SUBJECT: WESTINGHOUSE RESPONSES TO NRC REQUESTS FOR ADDITIONAL  
INFORMATION ON THE AP600

**Enclosed Responses to NRC Requests for Additional Information**

## NRC REQUEST FOR ADDITIONAL INFORMATION

Figure 440.435-1 Supply Tank Pressure.

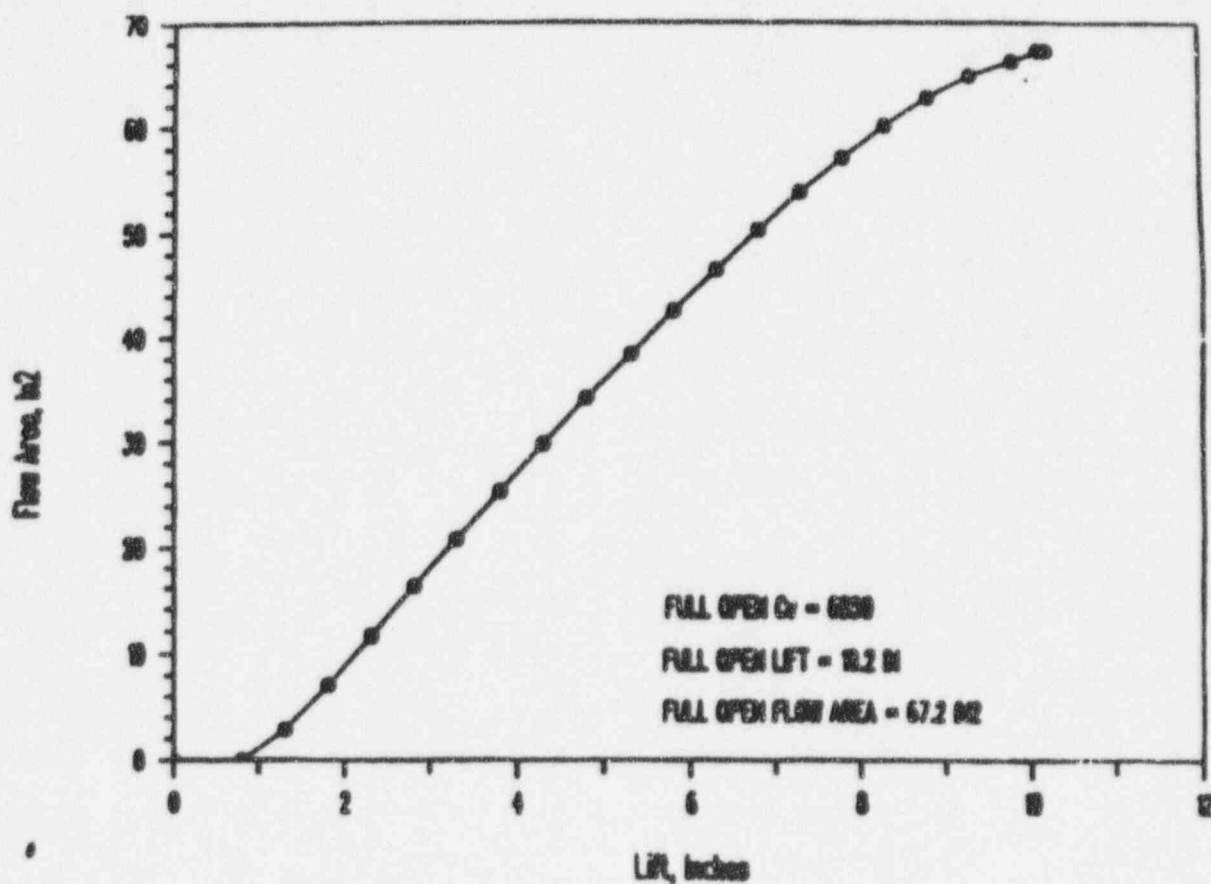
The flow quality data show an increase in quality within the first six seconds for all of the tests while NOTRUMP displays a decreasing trend. While the flow quality at the sparger discharge will establish the depressurization rate for the system, the miscalculated flow quality, particularly in the beginning of each test, suggests that NOTRUMP is lacking dynamic effects. As such, explain how the two-region fluid model void distribution in the liquid regions is computed, and how this lower region void fraction affects the quality exiting a volume. Also, does the assumption that steam regions form above liquid regions affect the fluid void distribution in the ADS lines? That is, explain the conditions where separation occurs versus highly dispersed liquid-steam mixture conditions with void gradients and how NOTRUMP treats these conditions in the ADS lines. Are void gradients computed in the liquid regions? How is the release of steam from the liquid region computed; is it based on the average void fraction in the region or is a surface void fraction computed for release calculations? In vertical sections, during depressurization transients or vertical regions with high heat addition, large void gradients can develop where the surface void fractions can be two to three times greater than the average. Please explain how NOTRUMP treats the void distribution and release of steam from the two-phase regions under these conditions?

Figures 440.435-1 and 440.435-2 show that in ADS Test 240 both the pressure and the mass in the supply tank are constant in the first 3.5 seconds, then decrease after 3.5 seconds. This means that VLI-1 gate valve did not open at time zero, rather it actually opened at 3.5 seconds. There are many reasons for this. First, the valve was initially very tightly closed. Therefore, when the power was applied to the gate valve, it took a period of time before the valve began to move. After the valve began to move, it took additional time to clear the seat and actually open sufficiently to allow flow to pass. Because of the shape of the gate valve, the valve opening area did not increase linearly at first, but increased very slowly, then gradually increases linearly increase as can be seen in figure 440.435-3. This is reflected in the pressure plot (Figure 440.435-1) and mass plot (Figure 440.435-2), where the curves change gradually, instead of sharply changing, at 3.5 seconds when the valve is open.

In the NOTRUMP simulation, the valve is assumed to open linearly from the time zero. To have a comparison between the NOTRUMP calculations and the data, it is necessary to find the effective opening time of the valve in the test. This is accomplished by intersecting the linear portion of the pressure curve (Figure 440.435-1) with the initial horizontal line, which is 3.5 seconds. Therefore, the comparison of Test 240 in reference 440.435-1 should be corrected by shifting the data curves to the left by 3.5 seconds so that the actual VLI-1 valve opening time is at time zero. The results are shown in Figures 440.435-4 through 440.435-13 (The original unshifted plots in reference 440.435-1 are shown following each shifted plot). It is seen that the agreement between the NOTRUMP calculated quality and the quality calculated from the data is much better. A similar time shift is applicable to other tests.

Figure 440.437-1 Steam/Water Supply tank (Prepurifier)

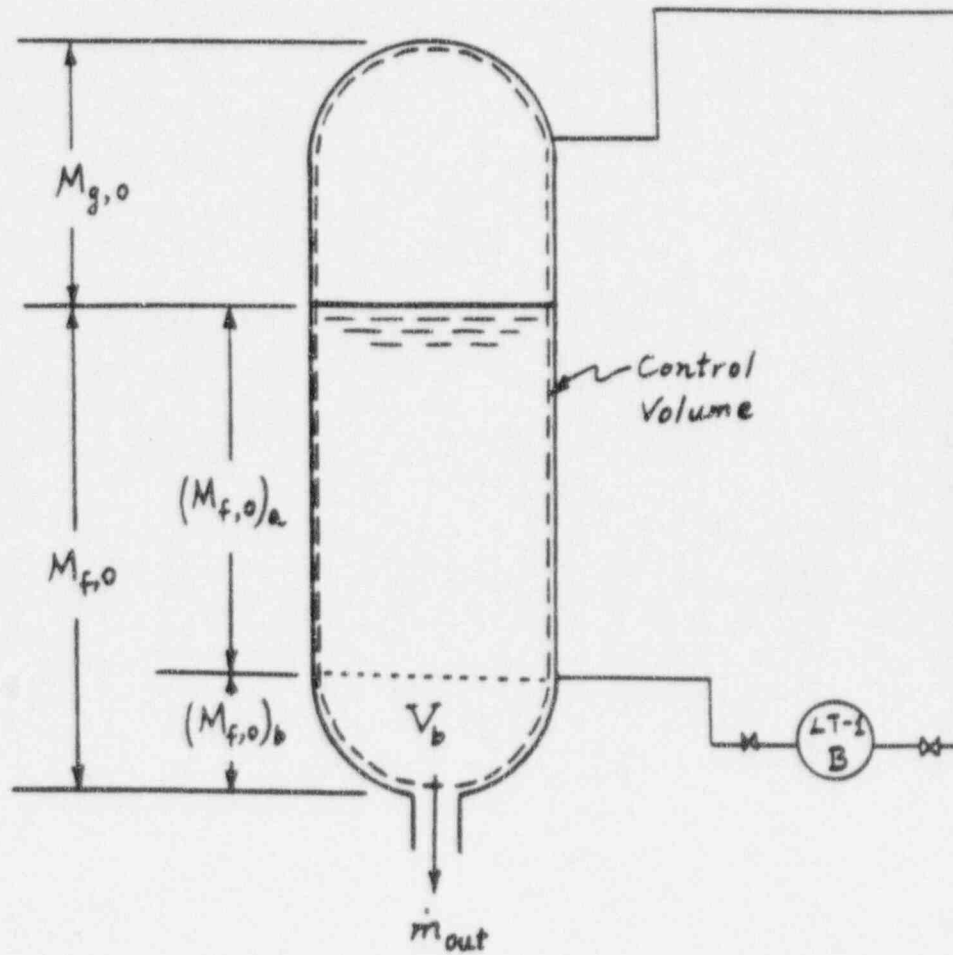
NOTRUMP overpredicts the depressurization rate in the pressurizer for several tests while the fluid qualities in the ADS lines for these tests were underpredicted. Since lower quality should lead to a reduced depressurization rate, please explain this inconsistency. See for example Figs. 4-13, and 4-33, 4-53. Also, these tests are only displayed for 30 seconds and only capture the very initial short period of the depressurization. Please explain why the comparisons were not carried out beyond 30 seconds or until atmospheric pressures are approached. Some of the tests show a marked deviation between the data and the NOTRUMP prediction suggesting the long term depressurization may be grossly overpredicted as in Figs. 4-53, while the flows show a growing discrepancy with the data as in Figs. 4-32 and 4-12 at 30 seconds. Since the ultimate judge of the ADS is its ability to depressurize the system to very low pressure, displaying the test comparisons for only the first 30 seconds where the system remains at elevated pressures does not demonstrate the NOTRUMP code ability to predict ADS depressurization over the full range of system pressures. Please provide the NOTRUMP comparisons to the data until the system has completely depressurized.

To show that the depressurization of the pressurizer depends only on the flow rate but not on the fluid quality, consider the control volume enclosing the pressurizer volume as shown in Figure 440.437-1. The conservations of mass, energy, and pressurizer volume are:

and the depressurization rate depends only on the flow rate,  $\dot{m}_{out}$ . The larger the flow rate,  $\dot{m}_{out}$ , the larger the depressurization rate. Since NOTRUMP overpredicts the flow rate, it also overpredicts the depressurization rate, which is correct no matter what flow quality downstream is predicted.
